Re: **Summary of the sixteenth Weekly Inspection of Lost Creek ISR LLC's Permit 788**

Wyoming Department of Environmental Quality (WDEQ)- Land Quality Division (LQD)
Inspection Memorandum

File: Lost Creek ISR, LLC – Permit 788

Subject: Sixteenth Weekly Inspection

Photo Number 12: This depicts the calibration check sheet (log) for the cement balances being used at the site. Two are currently being used: one aluminum balance and one black balance.

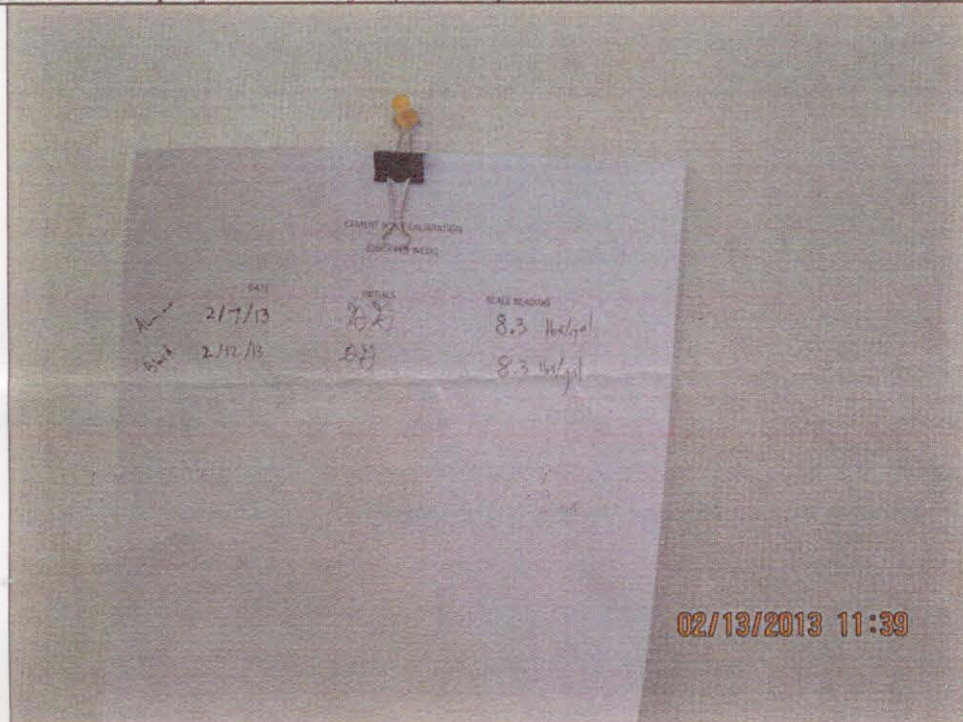
Mr. Lueders indicated the location of a cement balance calibration sheet (see attached Photo Addendum) in the temporary office. This was in response to last week's observation that the cement balance being used by the drillers was reading about 2 ppg too high. Since then, LCI have begun to use two new cement balances (both of which were calibrated prior to use). The old cement balance will be refurbished (cleaned) and calibrated before using it again. The calibration of cement balances will occur weekly. LQD appreciates LCI's attention to this topic.
